**SECTION 00 90 03
BIDDING AND CONTRACT REQUIREMENTS
ADDENDUM NUMBER 3**

Re: ADDENDUM NUMBER (3) TO THE BIDDING DOCUMENTS FOR

**McHenry County College
University Center at MCC**
Architect's Project Number: 22-050

10/6/2023 2:33:19 PM

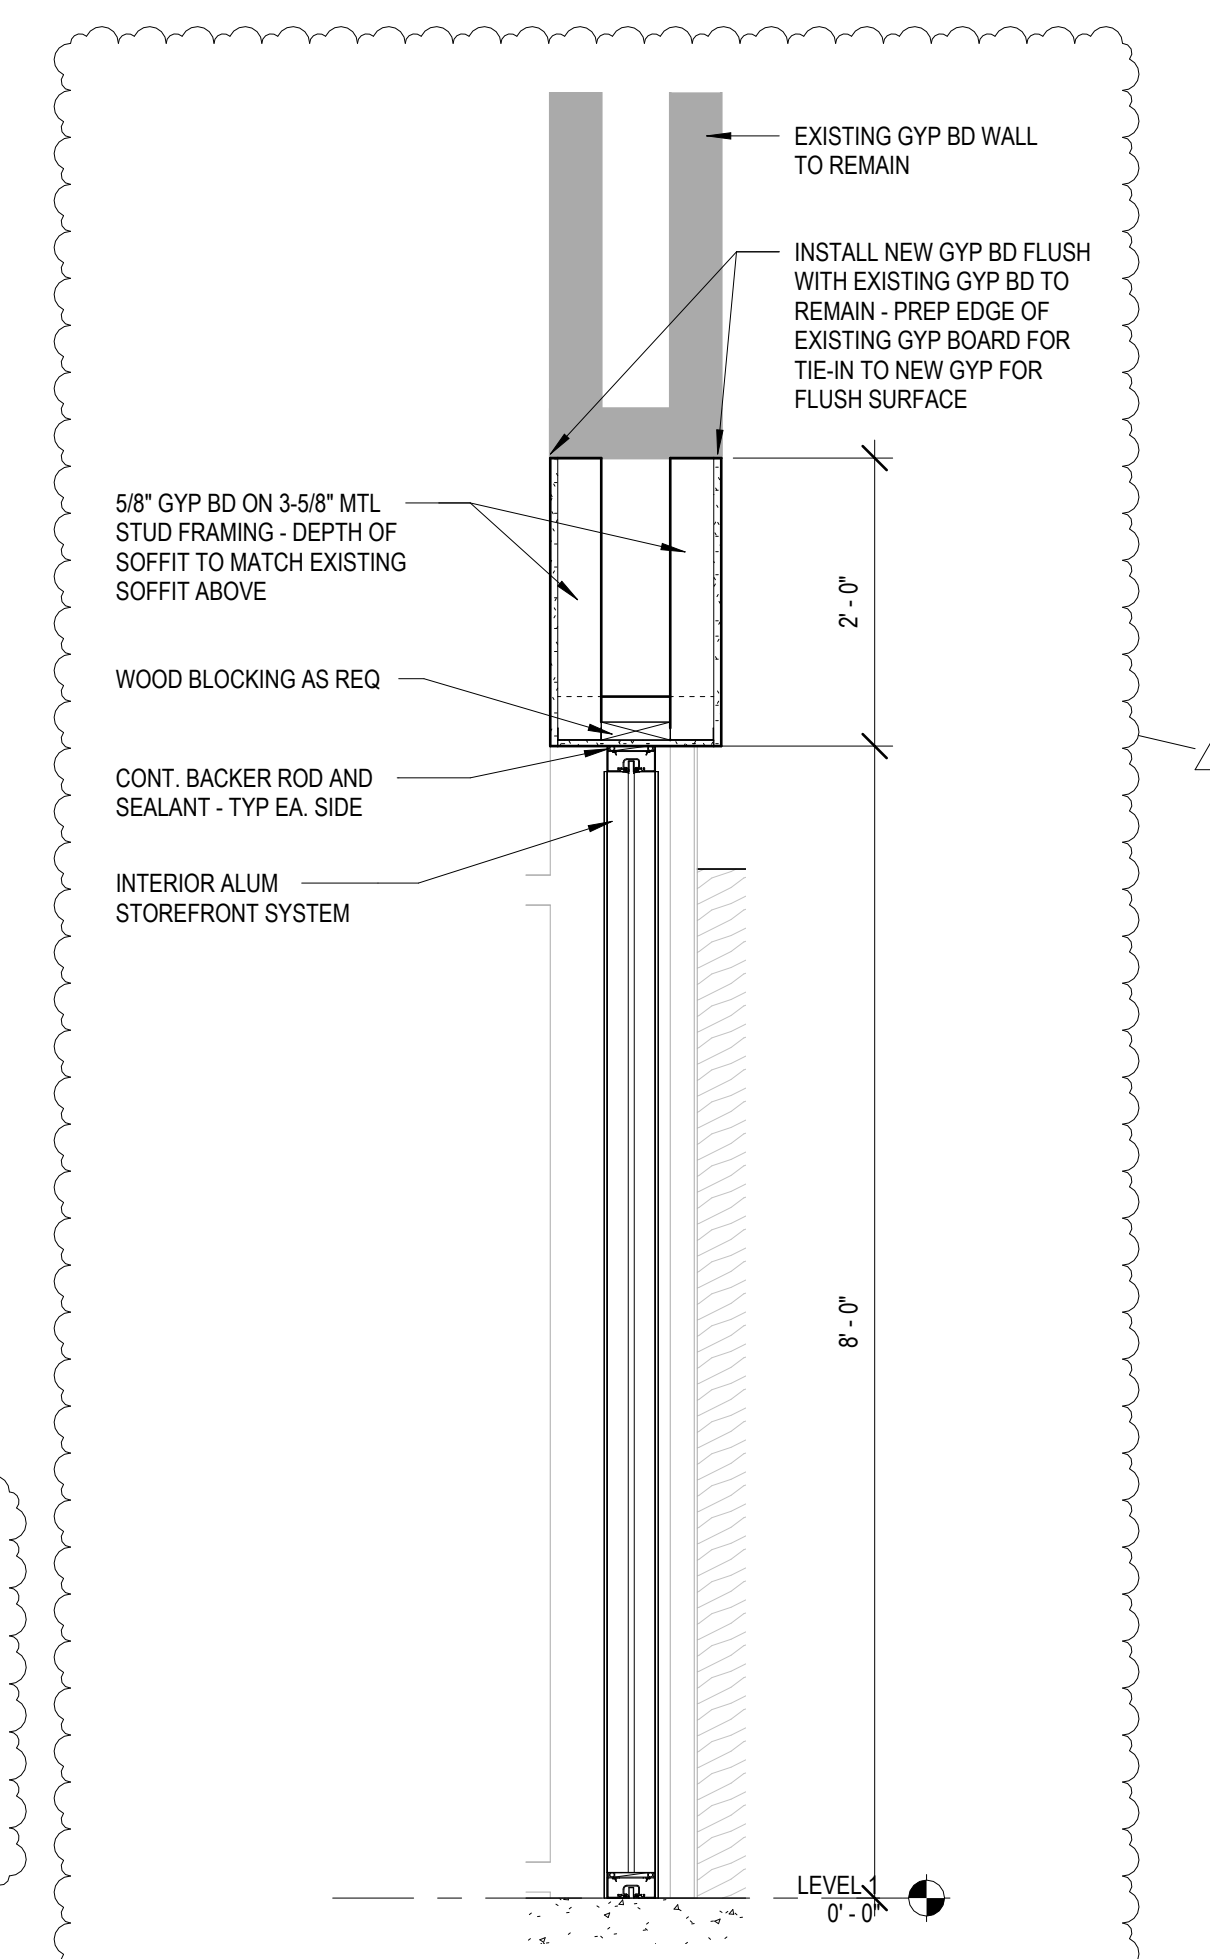
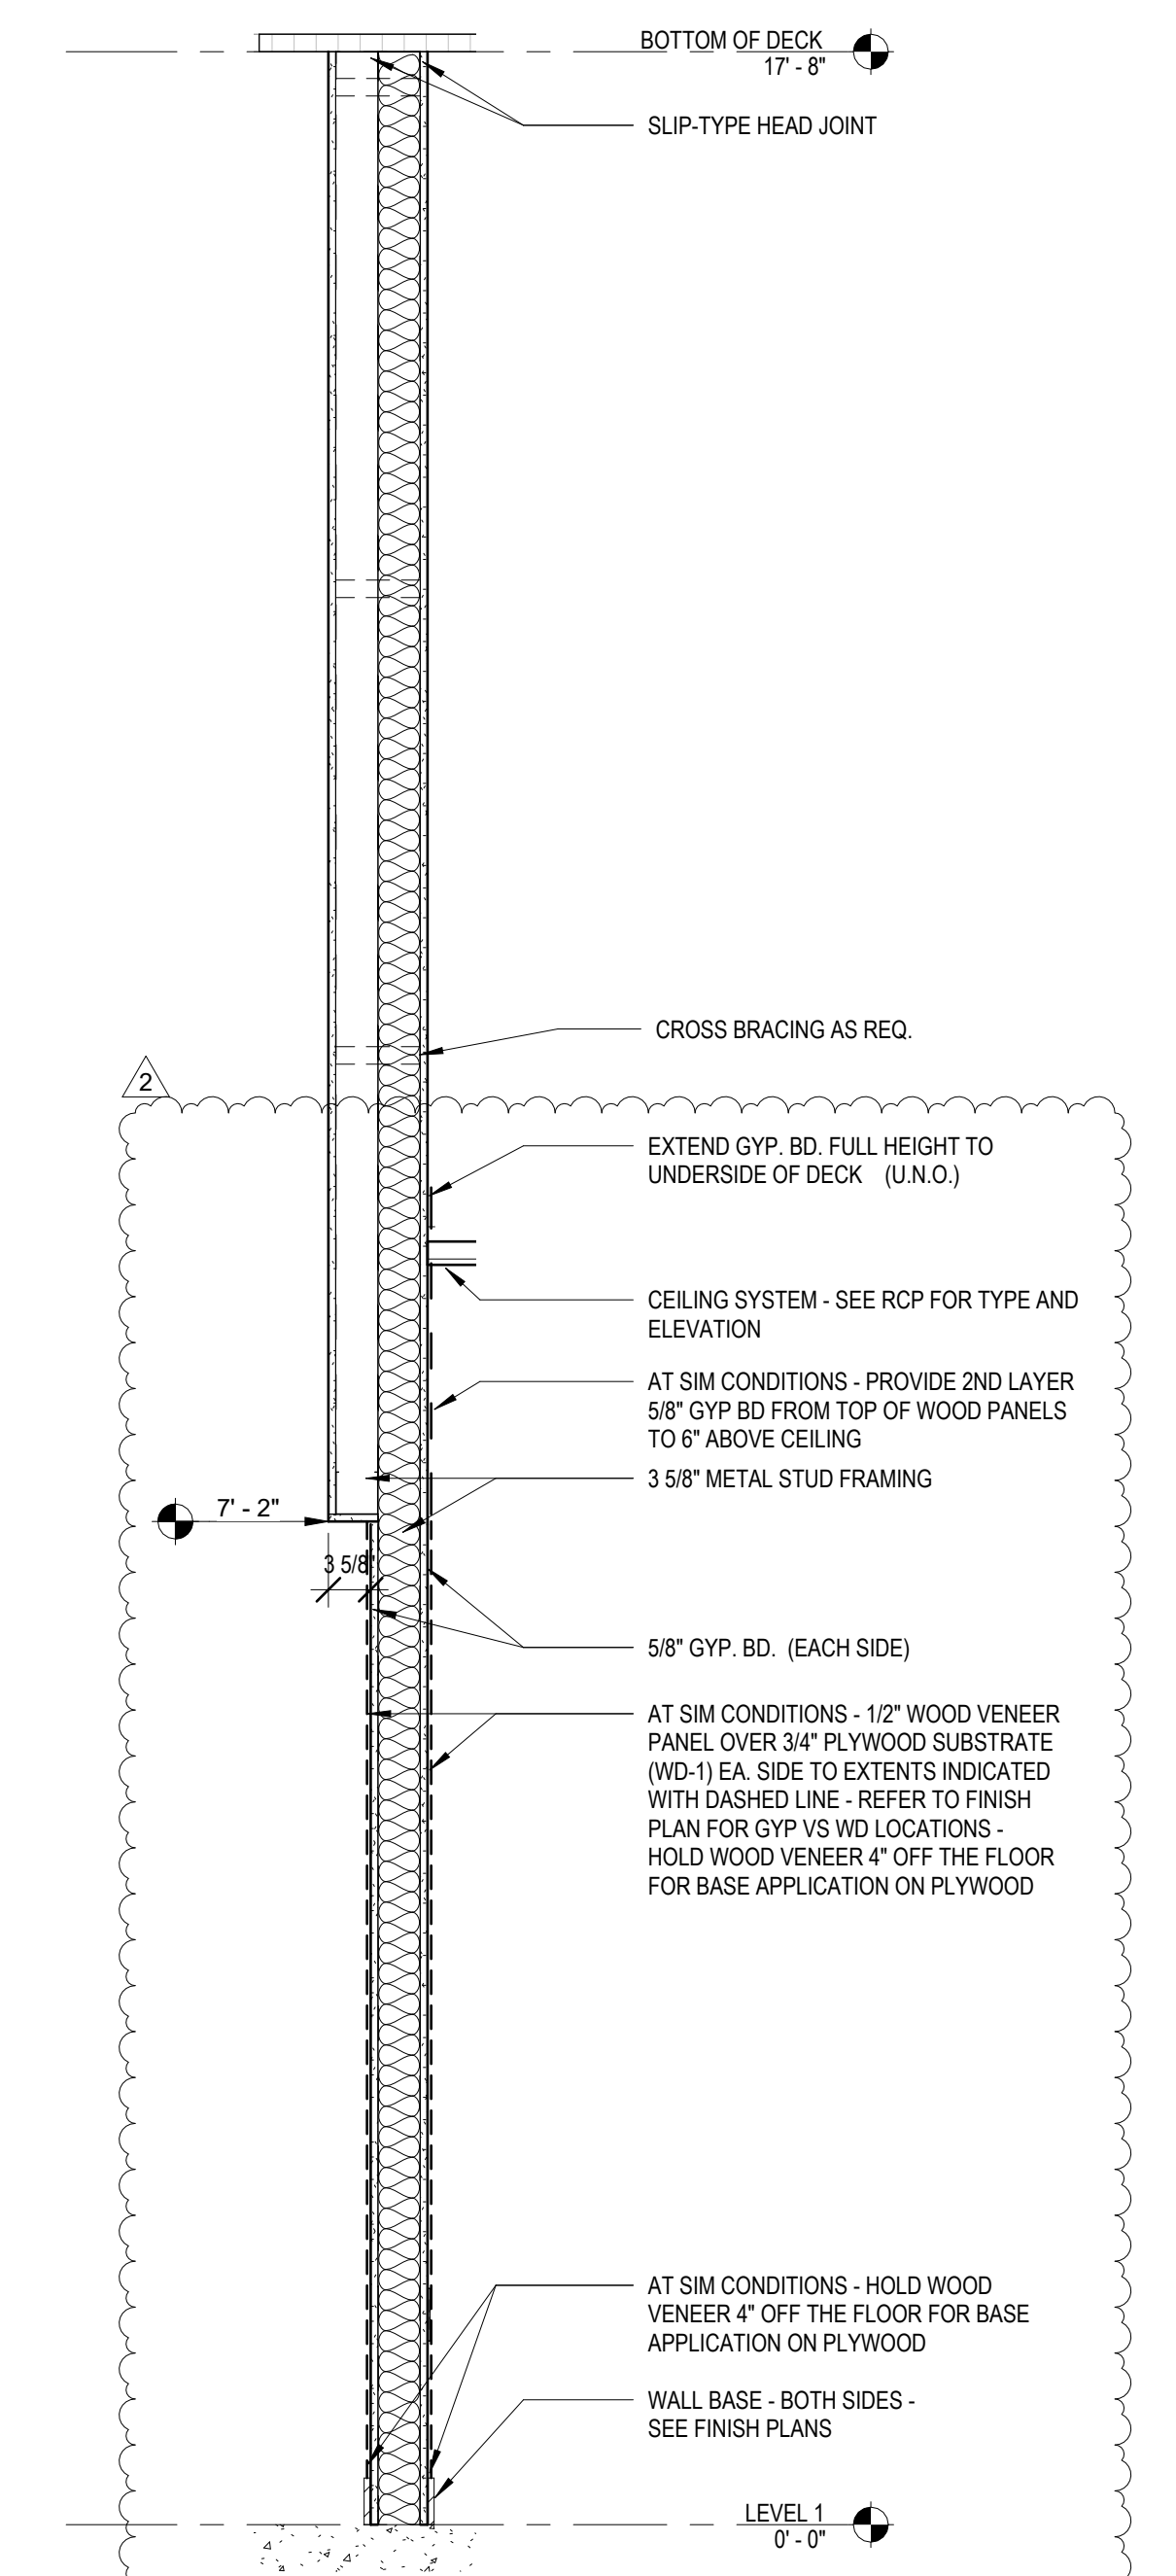
6. A5.01
 - A. **REVISE** section 1 as indicated to reflect section condition and sim conditions.
 - B. **REVISE** detail 11 as indicated.
 - C. **ADD** section 12 as indicated through window elevation A.
7. A9.51 / A11.01
 - A. **REVISE** WD-1, WD-2, WD-3, WD-4, and CP-1 as indicated.
8. A10.00
 - A. **REVISE** door and frame schedule as indicated.
 - B. **REVISE** detail numbering for numerical order. Clouds not indicated for clarity.
 - C. **REVISE** glass type indicated for window elevation A to GL-02 as indicated.

FP1.00

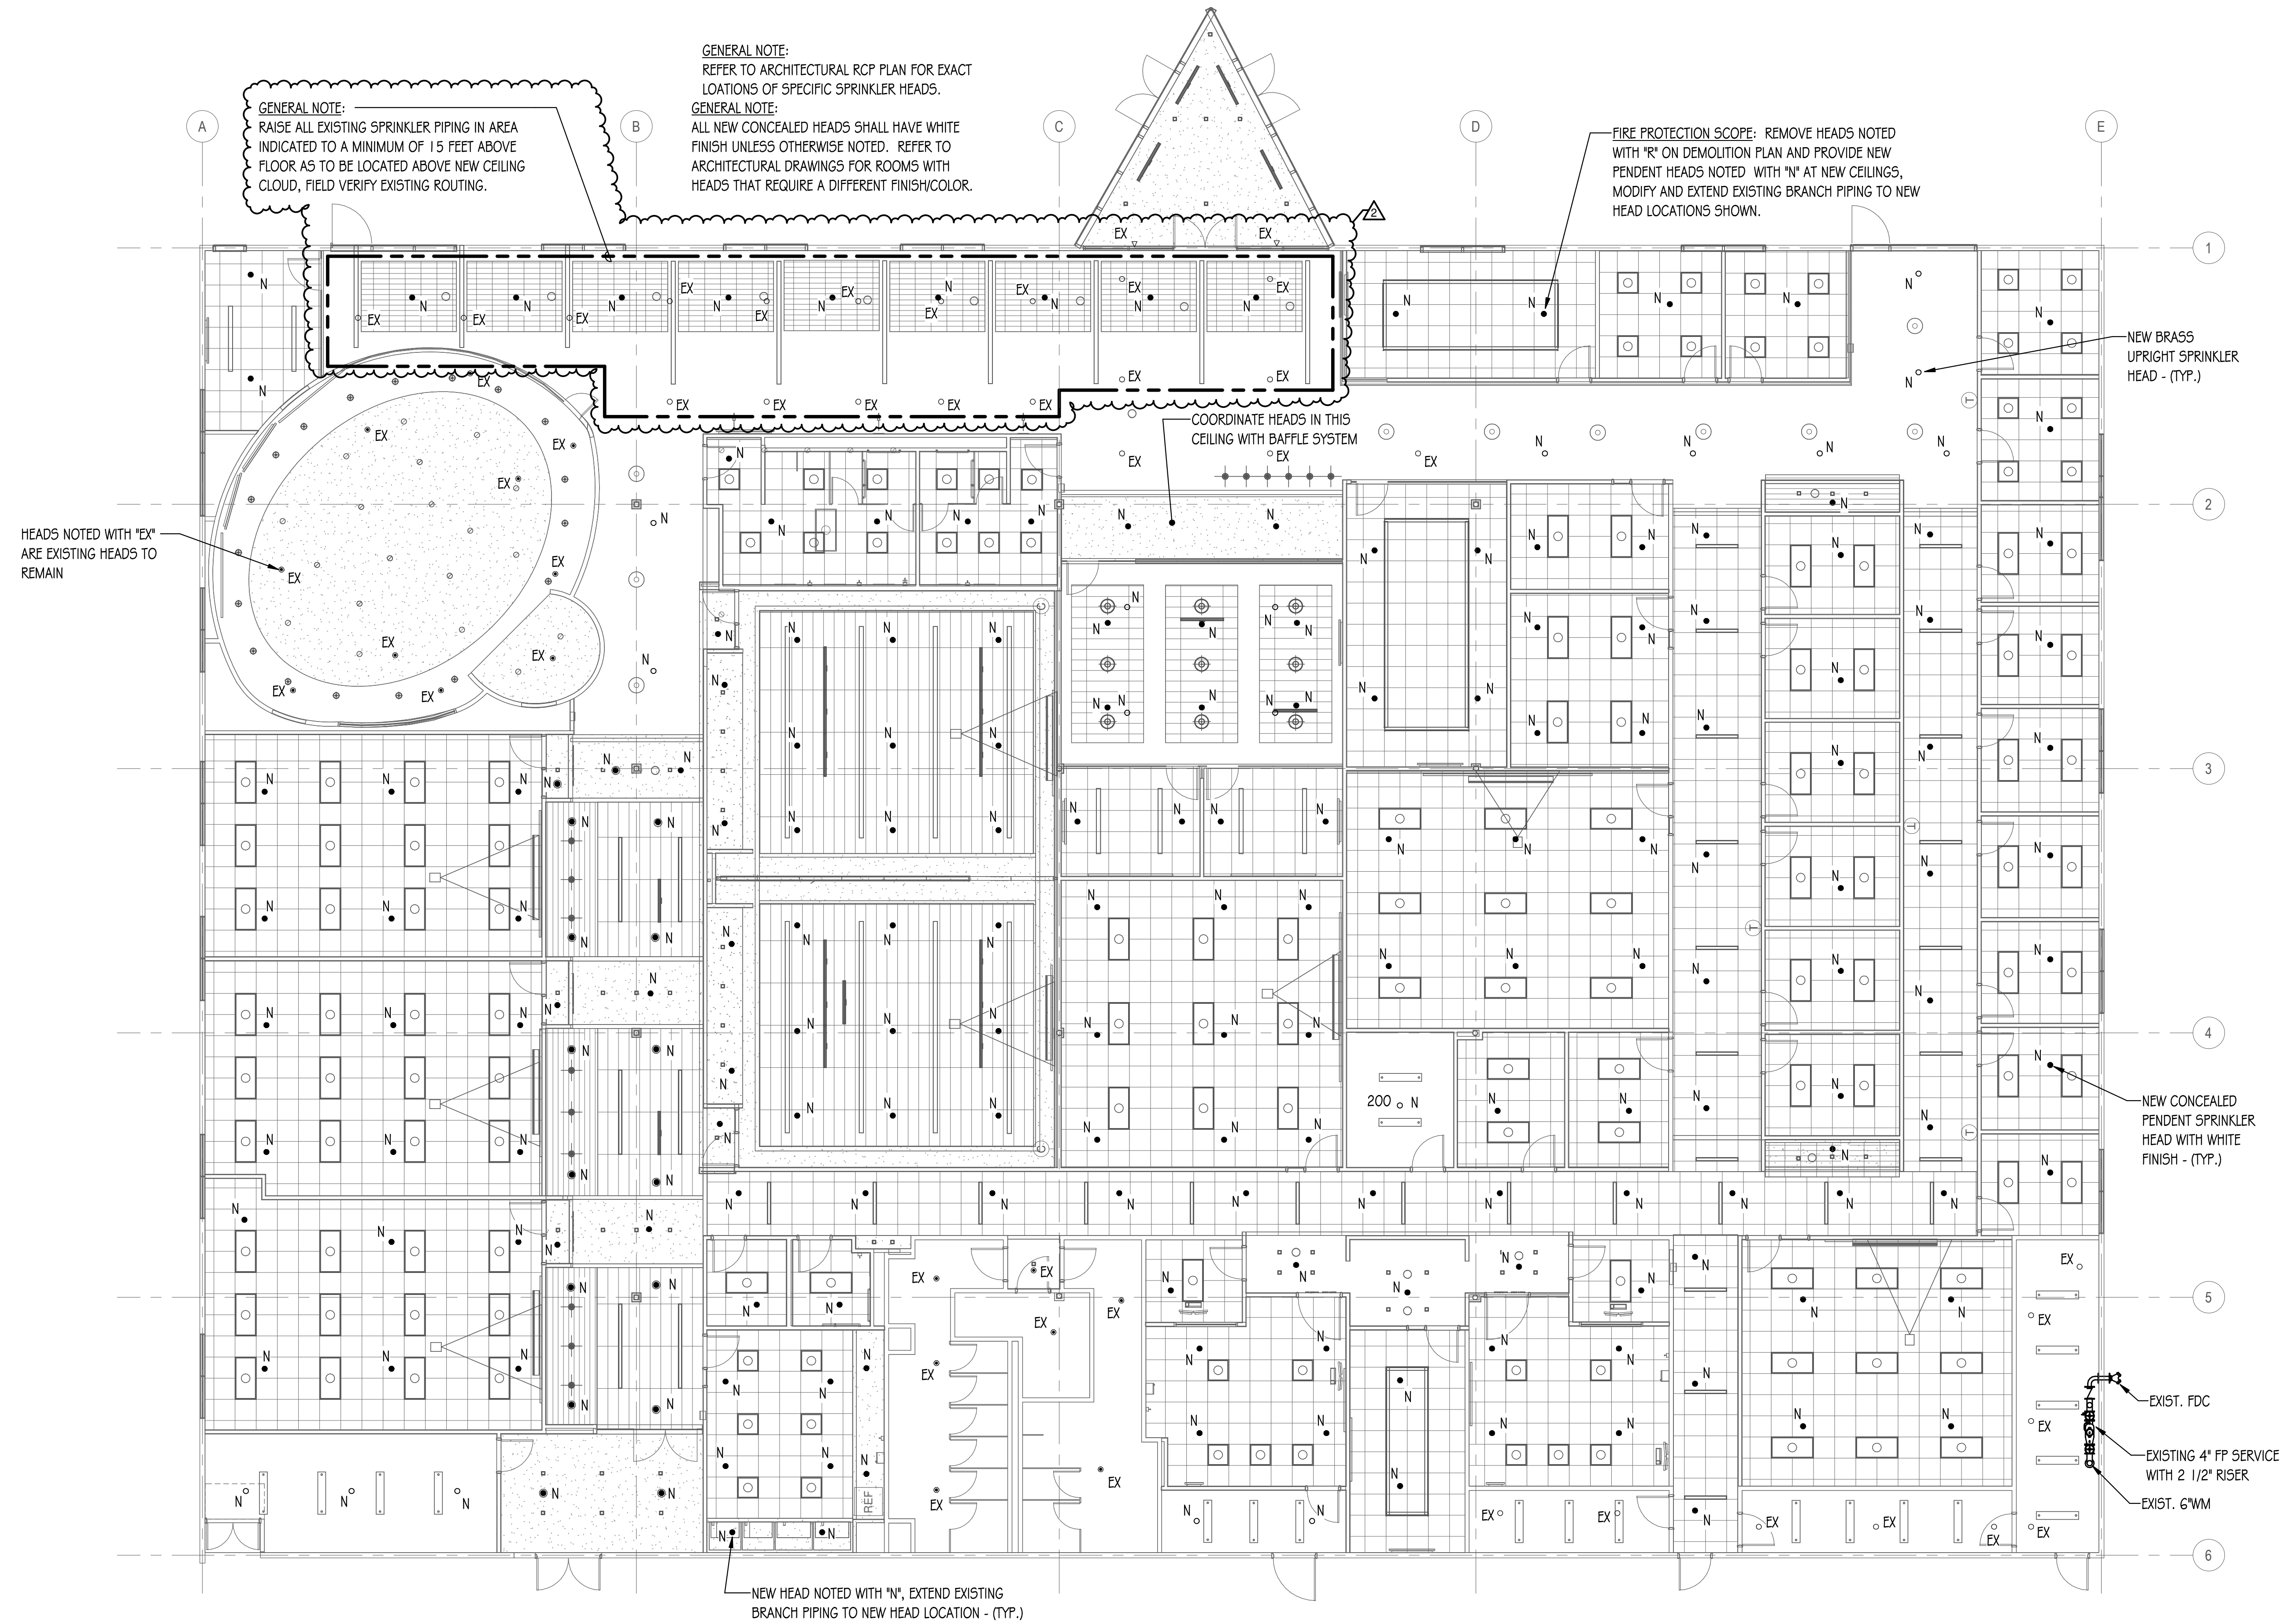
1. FP1.00
 - A. **ADD** note in Corridor C001.
